Aeronautical Study No.  
 2020-AWP-7967-OE

**\*\* DETERMINATION OF NO HAZARD TO AIR NAVIGATION \*\***

Structure: Building Scripps Mercy Replacement Hospital T1  
 Location: San Diego, CA  
 Latitude: 32-45-03.93N NAD 83  
 Longitude: 117-09-37.19W  
 Heights: 243 feet site elevation (SE)  
 254 feet above ground level (AGL)  
 497 feet above mean sea level (AMSL)

#### 6. BASIS FOR DECISION

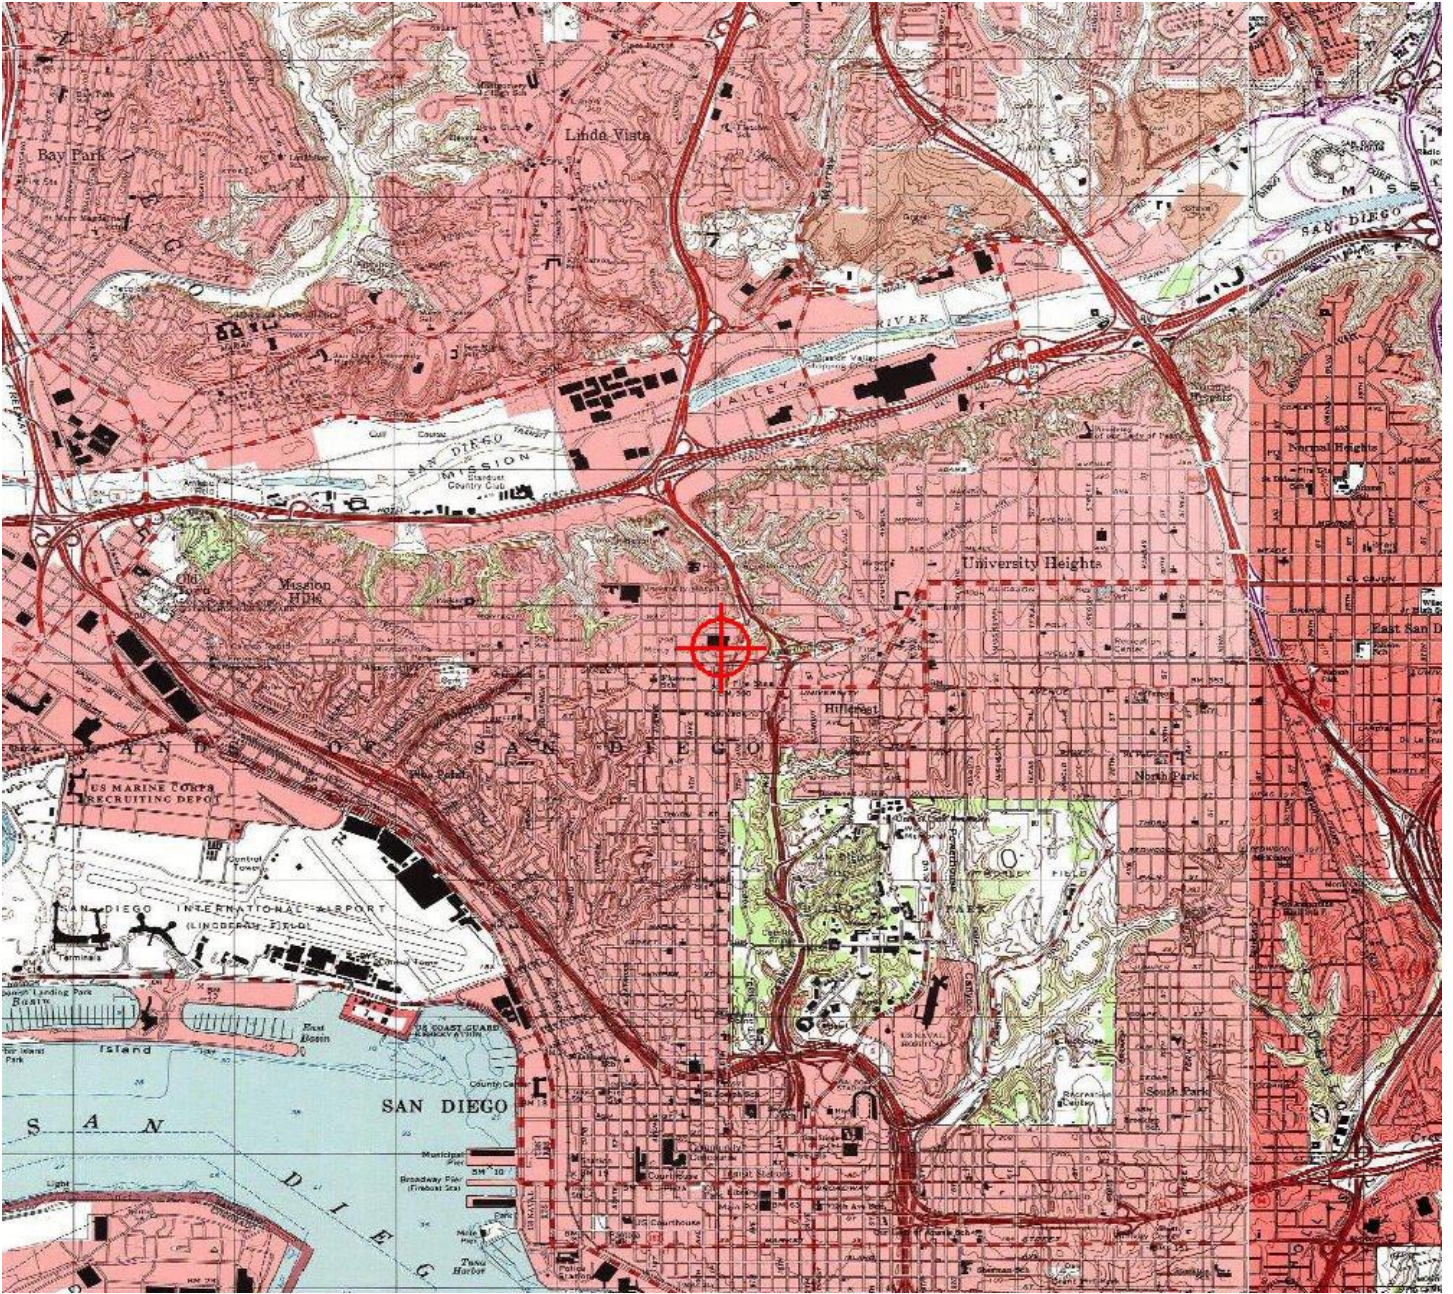
The proposed building would exceed the SAN horizontal by the values listed above, however, there are no IFR effects to any arrival or departure procedure. Even though the proposed structure would exceed the VFR conical surface by the values shown above; the terrain at this location also exceeds the horizontal surface by 77 feet. FAA Order JO 7400.2M, Procedures for Handling Airspace Matters, allows for traffic pattern airspace penetration exception on a case-by-case basis where the terrain is significantly higher than the airport elevation. This case falls within that exception, the difference between the airport elevation and the rising terrain is approximately 77 feet. In addition the VFR Traffic Pattern Airspace surface is already impacted by other structures that are closer to the airport and in close proximity to the proposed building. FAA Flight Standards Division and the US Navy concurred with the proposal. The incorporation of marking and lighting will provide additional conspicuity for VFR and IFR pilots flying in this vicinity of SAN airport.

#### 6. BASIS FOR DECISION

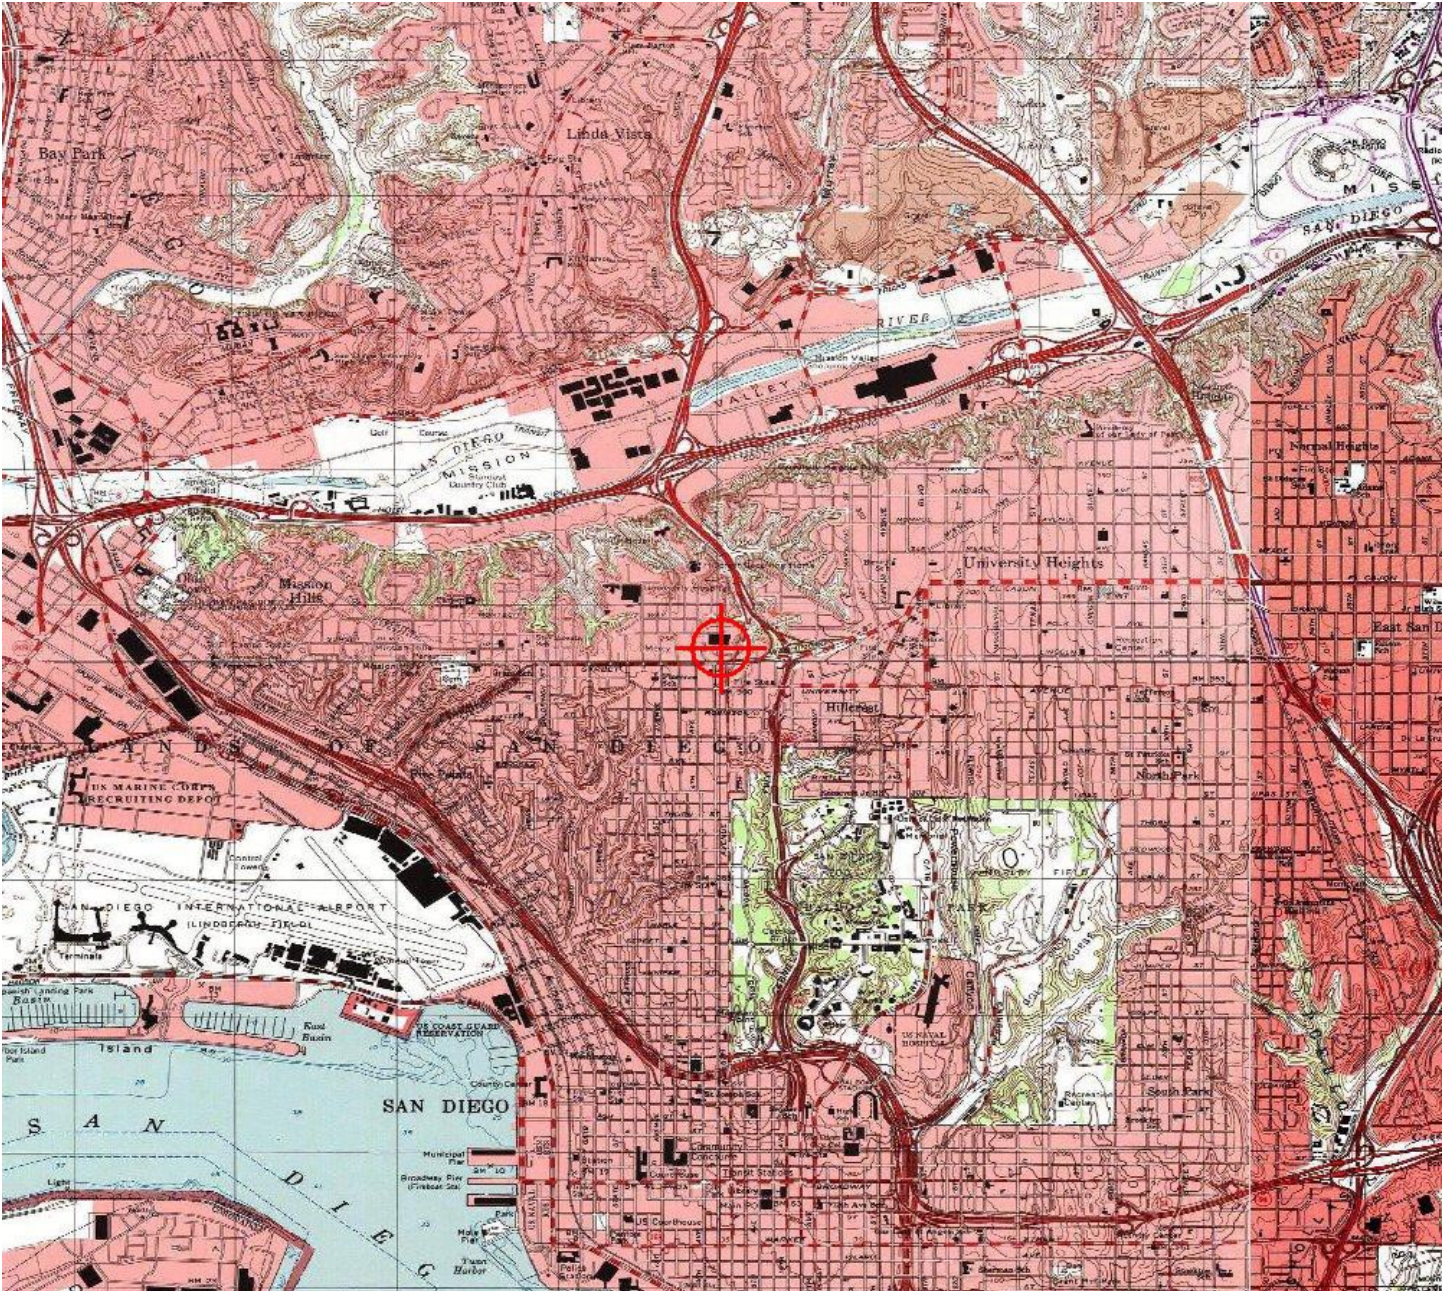
The proposed building would exceed the SAN horizontal by the values listed above, however, there are no IFR effects to any arrival or departure procedure. Even though the proposed structure would exceed the VFR conical surface by the values shown above; the terrain at this location also exceeds the horizontal surface by 77 feet. FAA Order JO 7400.2M, Procedures for Handling Airspace Matters, allows for traffic pattern airspace penetration exception on a case-by-case basis where the terrain is significantly higher than the airport elevation. This case falls within that exception, the difference between the airport elevation and the rising terrain is approximately 77 feet. In addition the VFR Traffic Pattern Airspace surface is already impacted by other structures that are closer to the airport and in close proximity to the proposed building. FAA Flight Standards Division and the US Navy concurred with the proposal. The incorporation of marking and lighting will provide additional conspicuity for VFR and IFR pilots flying in this vicinity of SAN airport.
